Access Compliance Report

Public Rights-of-Way

(Curb Ramps)

Intersection ID: 49224	Main Street: ANNA_GARRISON_RD	Cross Street: ALEXANDER_PARK_DR	Location: S
ADA ID: 7B0B79EB5F90	Ramp Type: PerpDiag	Initial Pass/Fail: Fail	Overall Compliance: No
Severity Score: 17.5			
Codes/Mitigation Info/Possible Solution		Field Measurements/Component Compliance

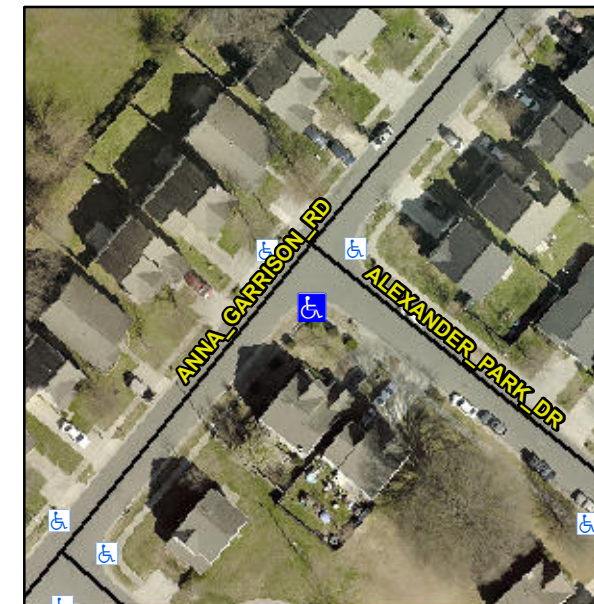
Not Found, R304.5.1

Compliance	Description	Data	Compliance	Description	Data
N/A	Ramp Length (in)	59.5	Yes	Ramp Slope (%)	5.7
No	Ramp Width (in)	34.5	Yes	Ramp XSlope (%)	0.9
N/A	Flare Type LT	N/A	N/A	Flare Type RT	N/A
N/A	Flare Slope LT (%)	N/A	N/A	Flare Slope RT (%)	N/A
N/A	Flare Traversable LT?	N/A	N/A	Flare Traversable RT?	N/A
N/A	Landing Length (in)	N/A	N/A	DWS Provided?	N/A
N/A	Landing Width (in)	N/A	N/A	DWS Contrast?	N/A
N/A	Landing Slope (%)	N/A	N/A	DWS Length (in)	N/A
N/A	Landing X Slope (%)	N/A	N/A	DWS Full Width?	N/A
N/A	Landing Curb? (Y/N)	N/A	N/A	DWS Offset (in)	N/A
N/A	Shared Landing?	N/A			
N/A	Gutter Ponding?	N/A	N/A	Gutter Slope (%)	N/A
N/A	Gutter Lip Ht (in)	0.5	N/A	Gutter X Slope (%)	N/A
N/A	Painted X Walk1?	No	N/A	Painted X Walk2?	No
	X Walk 1 Direction	To NE		X Walk 2 Direction	To NW
N/A	X Walk 1 Width (in)	N/A	N/A	X Walk 2 Width (in)	N/A
	X Walk 1 Slope (%)	2.0		X Walk 2 Slope (%)	3.9
	X Walk 1 X Slope (%)	1.9		X Walk 2 X Slope (%)	2.4

Remove & Replace Curb Ramp With Two New Directional Ramps or Equivalent.
